RE: Bertin Ranch Subdivision

I have reviewed the application to have RP04N45E247900 subdivided into four (4) lots to be known as the Bertin Ranch Subdivision and determined that the property is suitable for sub-surface waste disposal systems to serve residences. Two (2) test holes were excavated on September 1, 2022, to allow observation of the soil horizon to ten feet below natural grade. There is an existing septic system on the parcel serving a two-bedroom dwelling installed under Permit #4101011. The information gleaned from permitting and installation of this system is being used for this report as well. Following is my evaluation of the soils on the property. Both test pits presented basically the same soil layering with minor differences in thickness of the layers. (See included Test Hole Information page for greater detail.)

Bertin Ranch Subdivision
TEST HOLE LOCATIONS
Flat -
No surface water.

~ Test Hole Locations

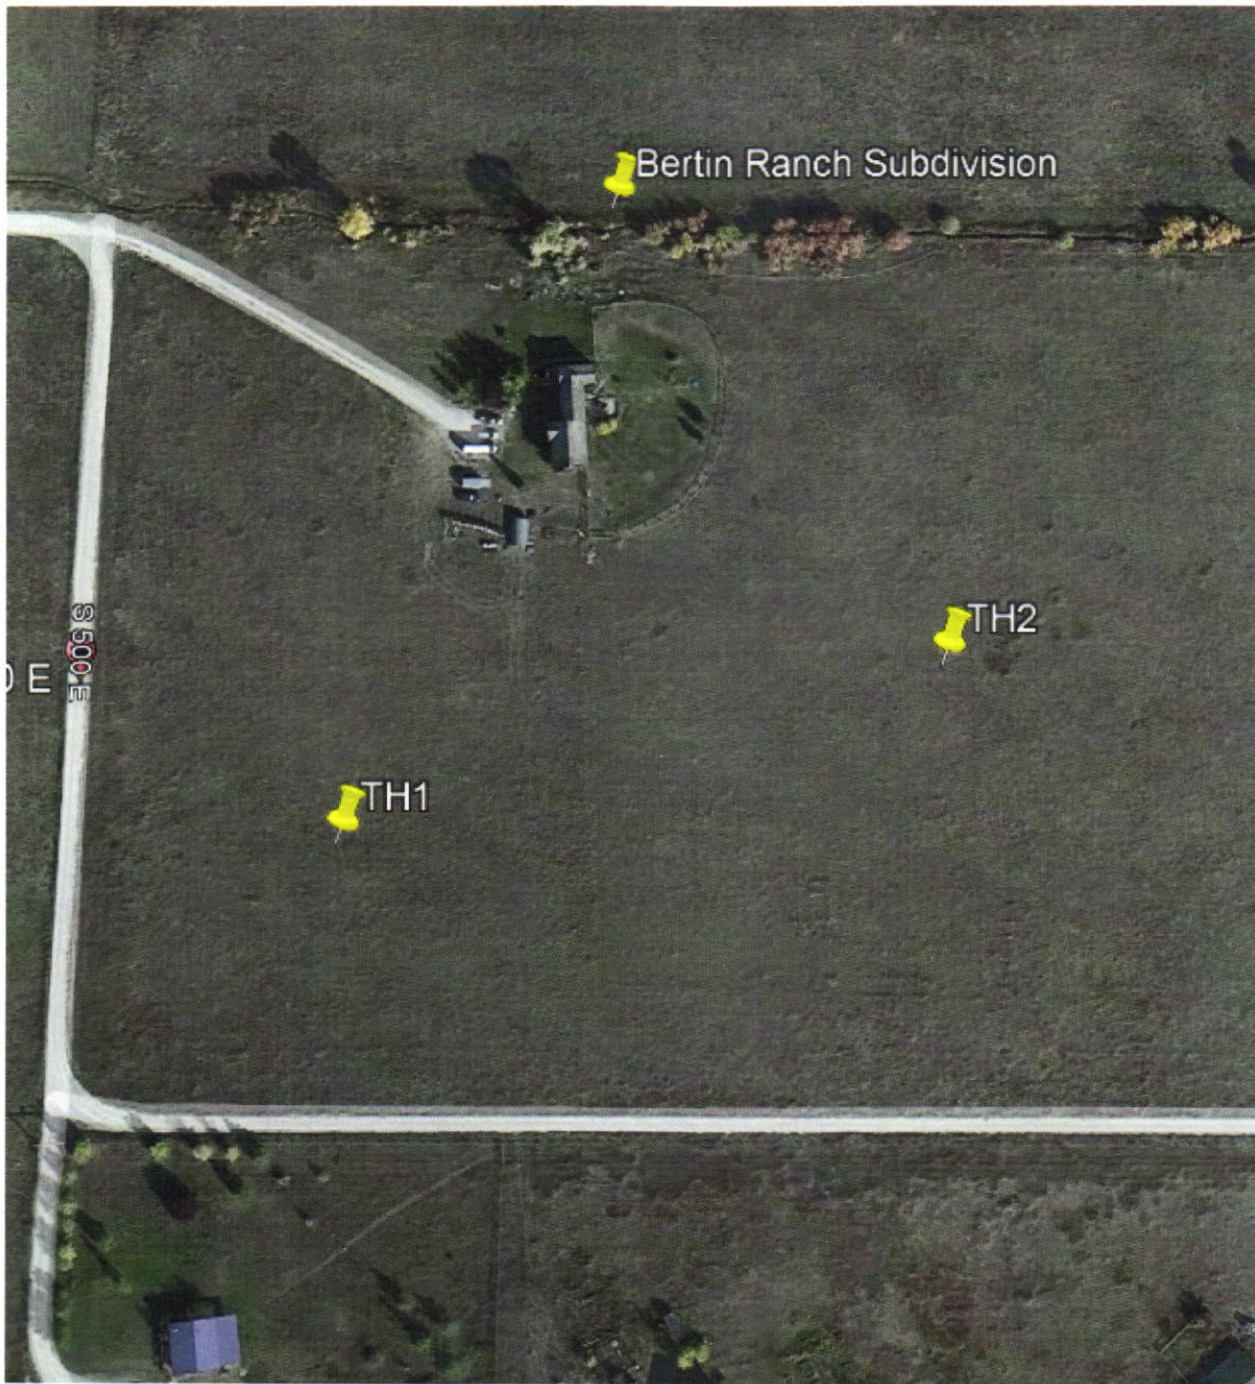
0~20 inches silty sand loam with no rock content. Topsoil with varying thickness. B1 soil type.
~20-120 inches gravely loamy coarse sand. 60% rock content of clasts 2-10 inches in diameter. A2A soil type.

Septic systems will be sized using B1 application rate of 0.6 gpd/sq ft due to the 60 percent rock content.

There is some calcification on the rock clast surfaces but no hardpan was encountered. This calcification will not impede permeability. No bedrock was encountered in any test hole. No groundwater was encountered in any test hole.

The entire parcel is flat with almost no undulation in topography. There was no surface water apparent at the time of evaluation. A small irrigation ditch runs along the north boundary of the parcel.

Eastern Idaho Public Health gives preliminary approval of the application to divide this parcel creating the Bertin Ranch Subdivision based on suitability for residential sub-surface waste disposal. Individual

subsurface sewage disposal systems may be allowed in accordance with IDAPA 58.01.03 and the Technical Guidance Manual for Individual Subsurface Waste Disposal. All current Idaho Rules must be met at time of installation.

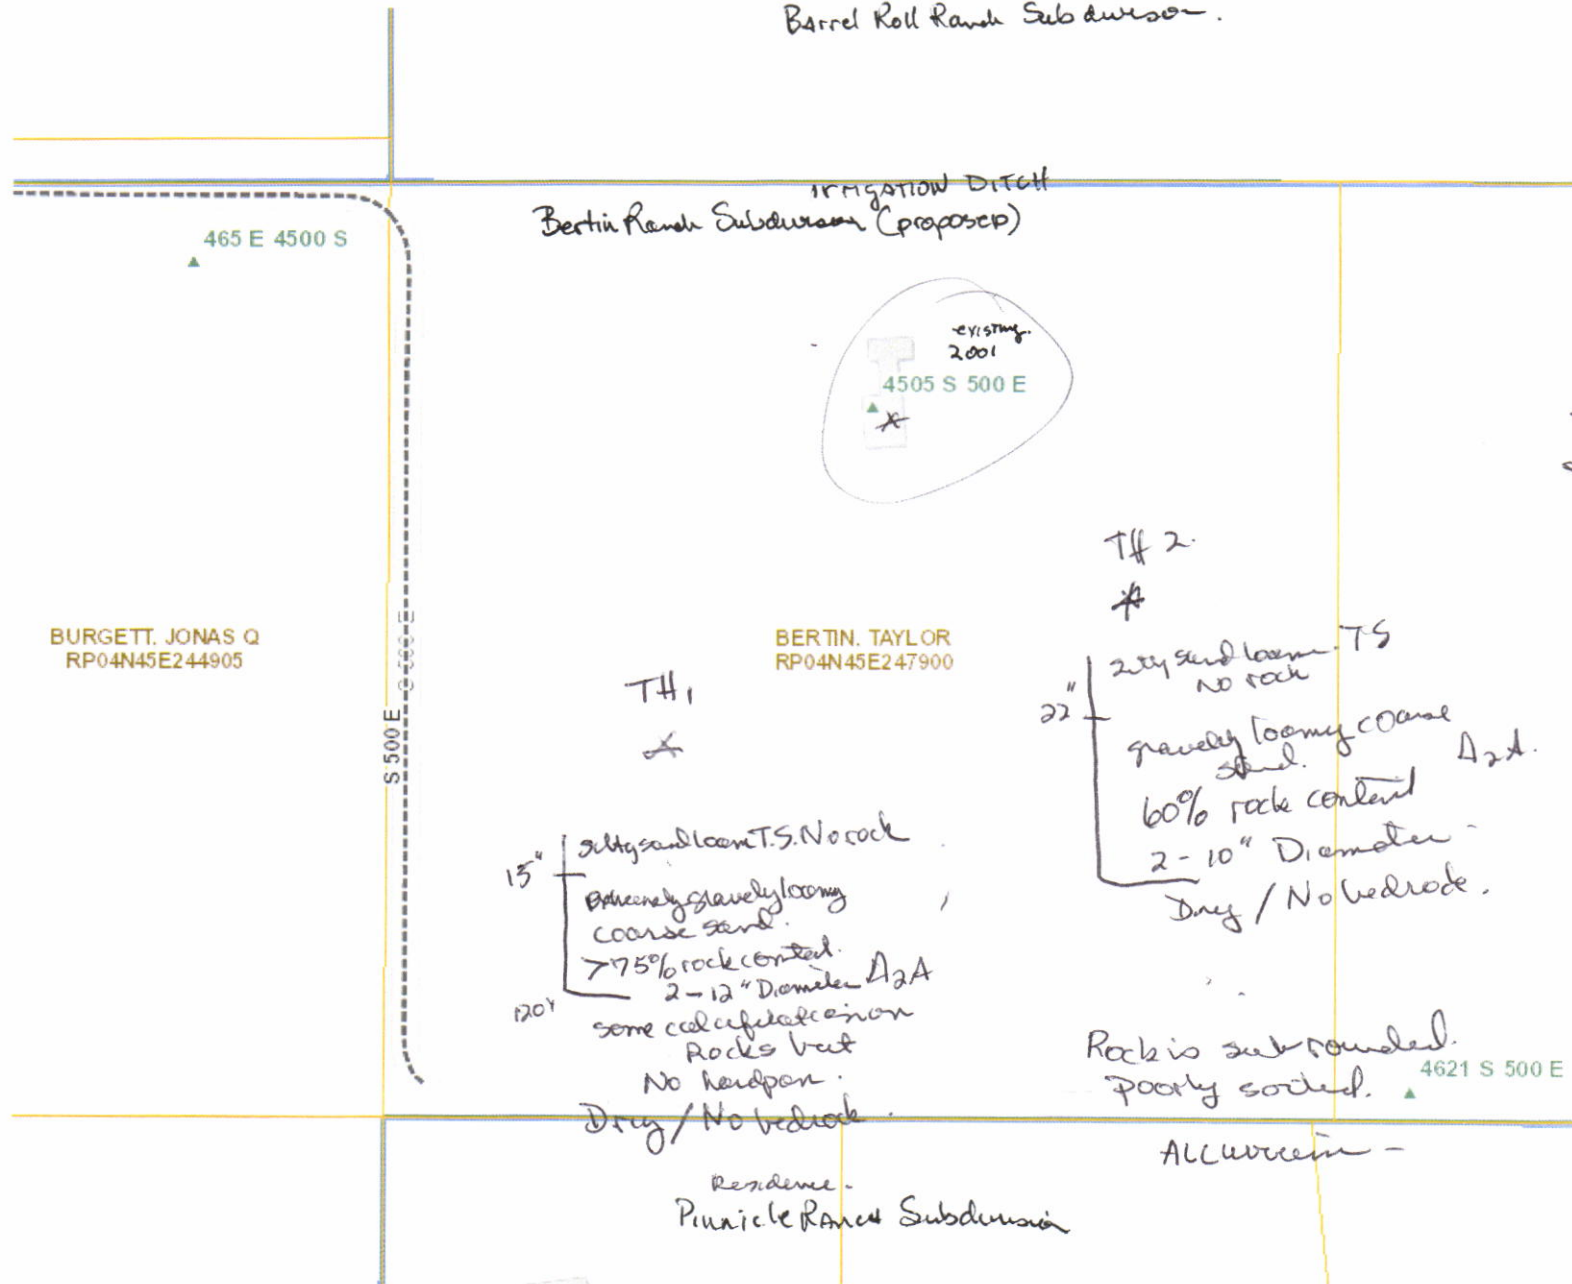
info from Raytech site eval. 2001
 Top soil.
 A₂A soil
 Very gravelly loamy sand.
 120" — Dry / No bedrock.

No concept map provided @ time of onsite.

Flat - one house on property - slight slope N to SW 1-2%

No surface water apparent
Pasture / Ag - Residential
photos on T#1.

Vegetation makes
difficult to
tell slope.
but it is minor
